1 IN THE DRAWINGS:

Appl. No. 09/640, 802
Amdt. Dated 05-15-2004
Reply to Office action of Feb. 23, 2004

FIG. 2

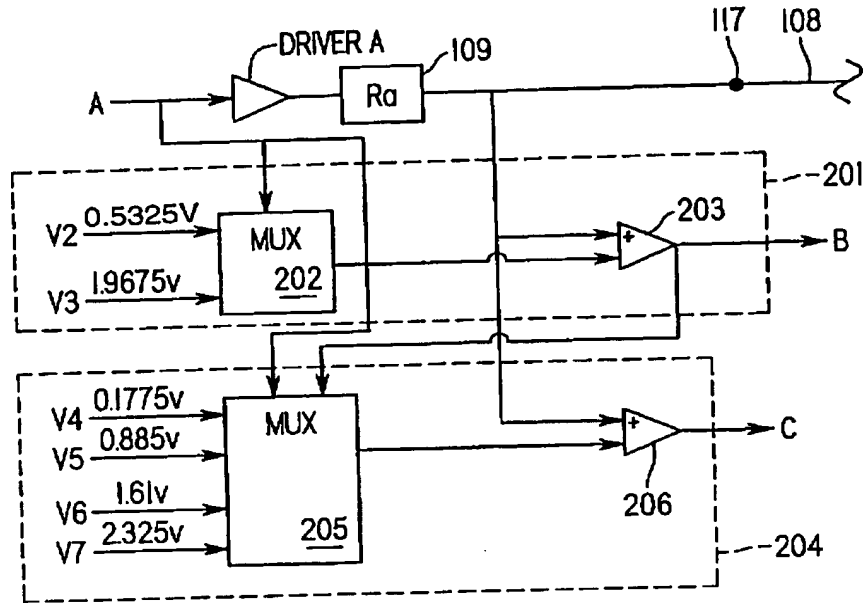
2 Enclosed with this response are three replacement drawing sheets. These replacement
3 drawing sheets replace originally filed drawing sheets 2, 3, and 4. The changes in these
4 replacement sheets address the Examiner's objections to the drawings. Specifically, in Figure 2,
5 the value associated with V2 is changed to 0.5325v. In Figure 4, the value associated with V2 is
6 also changed to 0.5325v and V1 is added next to the 1.25v input to differential receiver 402. In
7 Figure 6, reference numeral 618 is added to identify the inverter for signal B.
